Blair Creek Stream Mitigation Project

Year 1 (2022) Monitoring Report FINAL

Response to DMS Comments (January 19, 2023) for DRAFT Monitoring Year 1 Report.
Blair Creek Stream Mitigation Project, Clay County
Hiwassee River Basin: 06020002
DMS Project #100047 DEQ Contract #7415

Figure 5. Wetland Monitoring Well Graphs

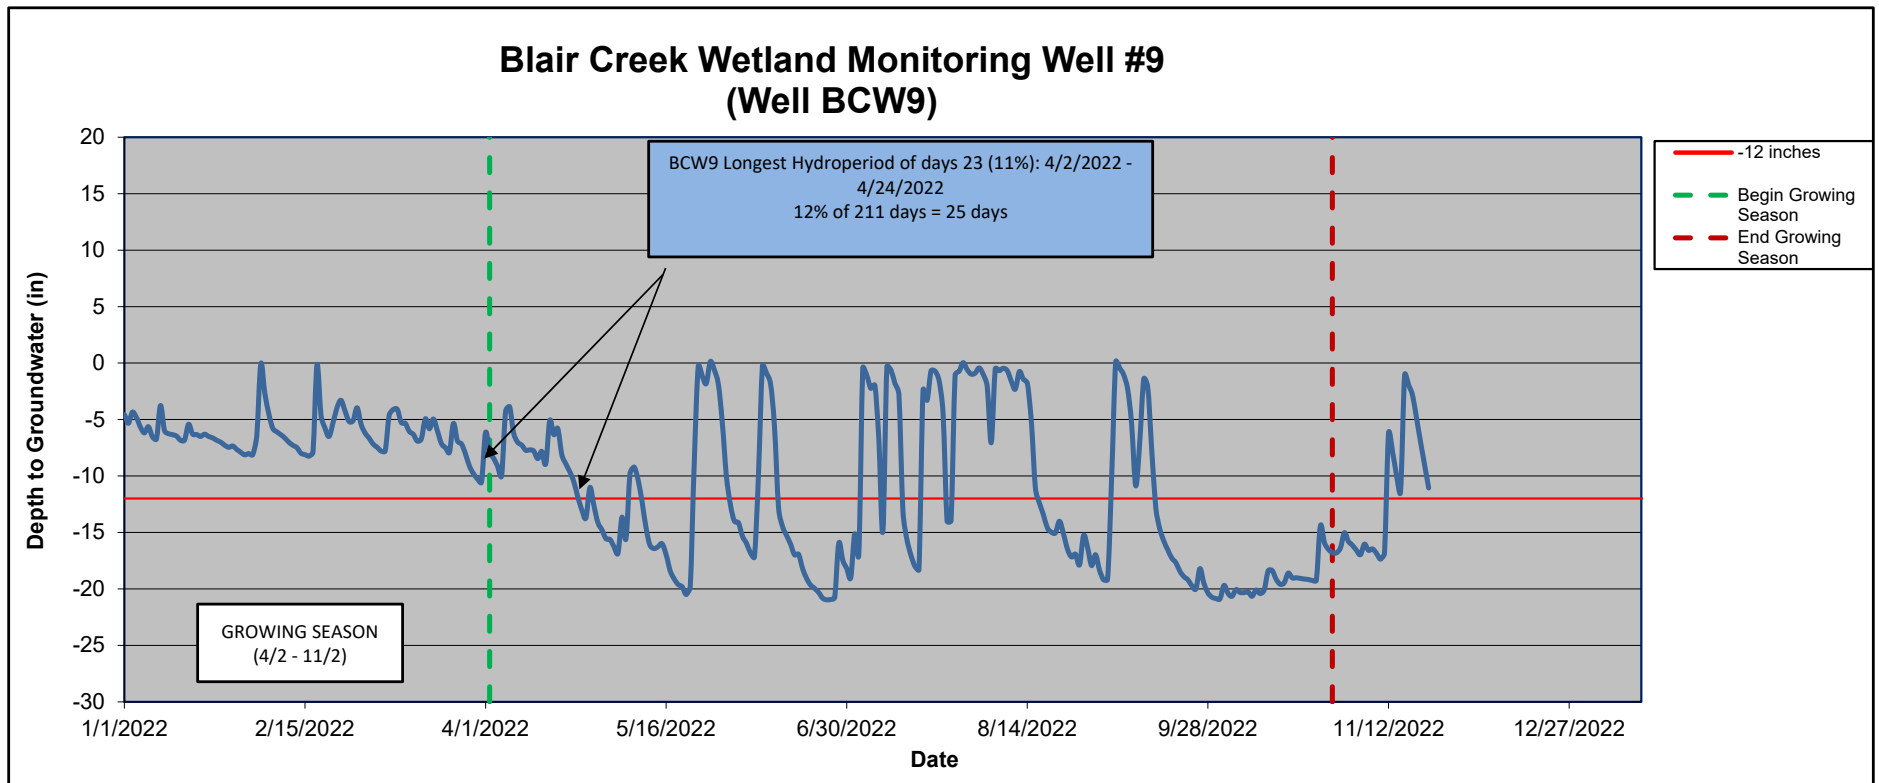
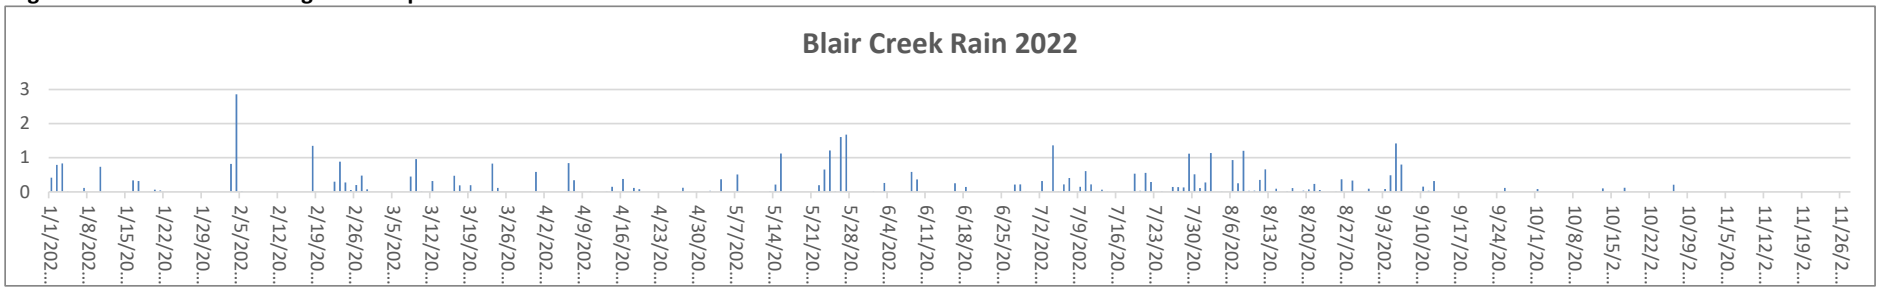
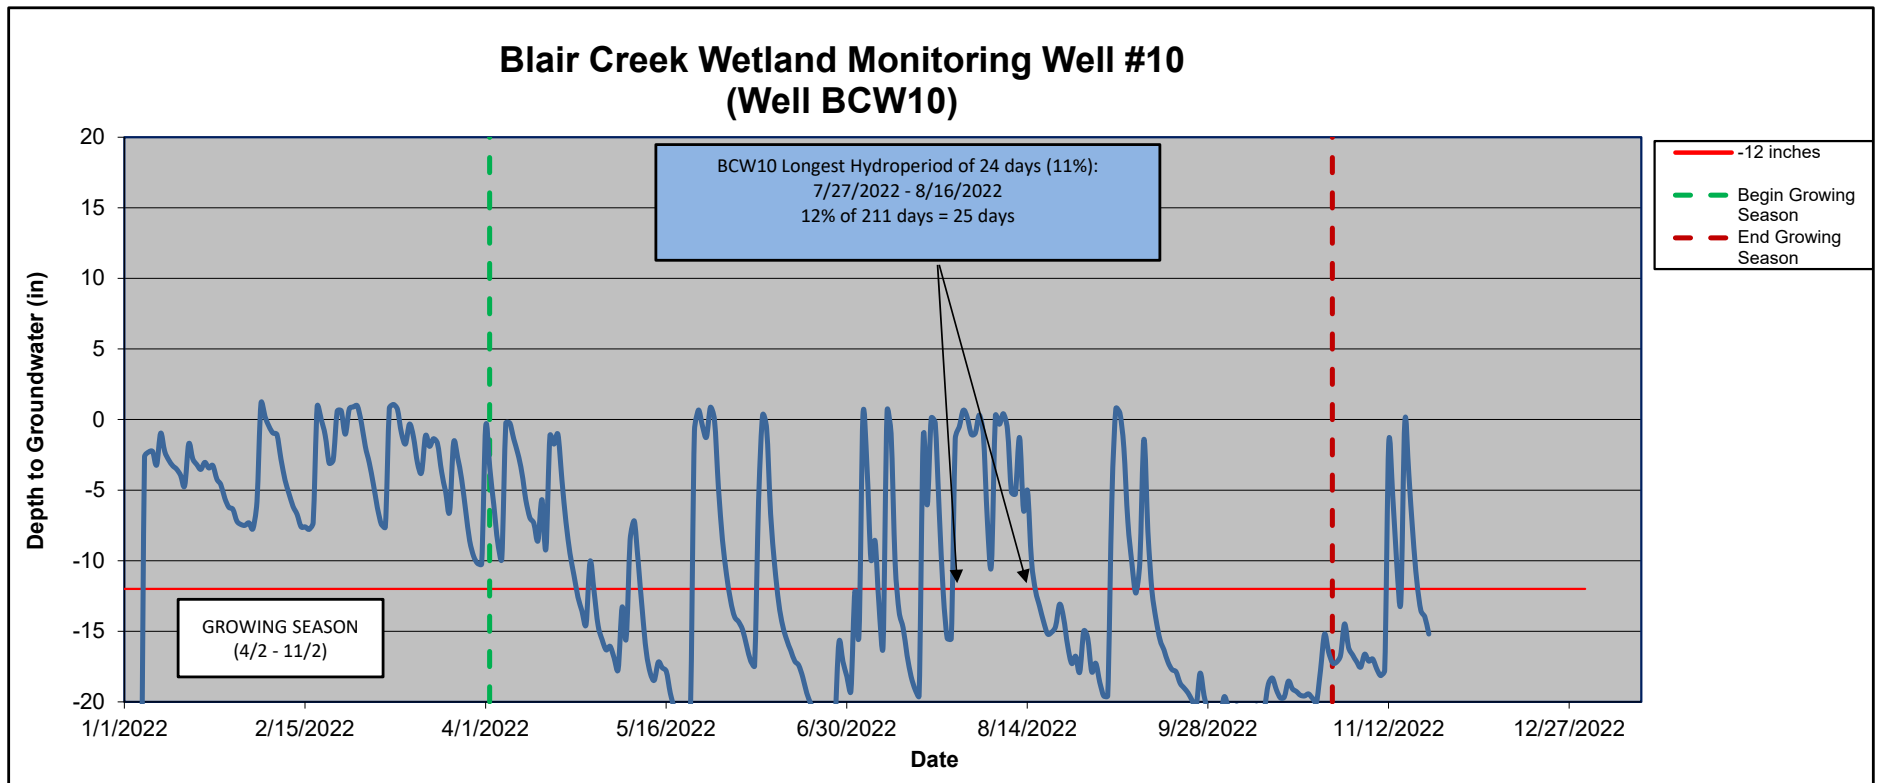
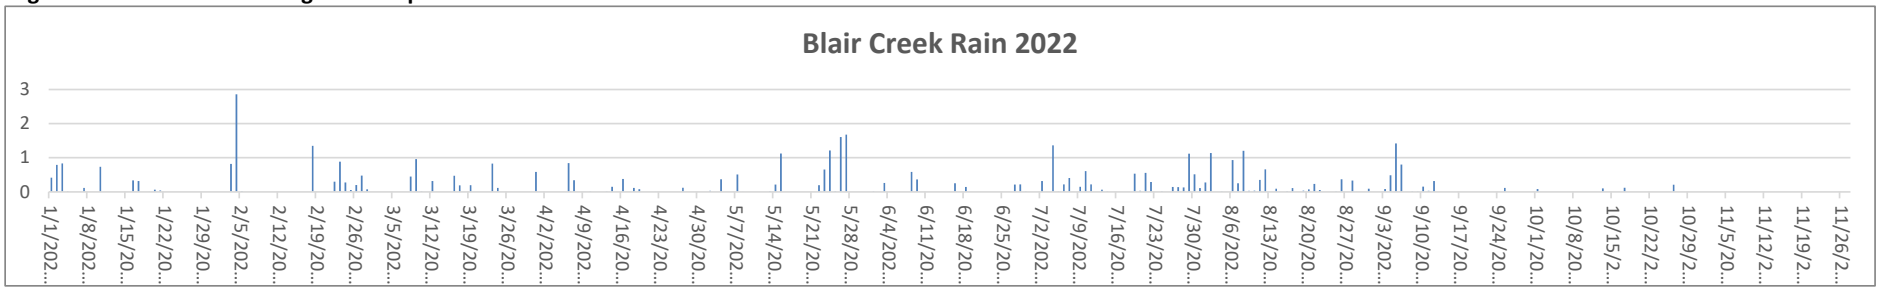
- Wetland gauge data was not included with draft digital deliverables. Please include raw data and spreadsheets used to produce figures with final submittal.

RESPONSE: *Wetland gauge data has been included in the electronic submission files as requested.*
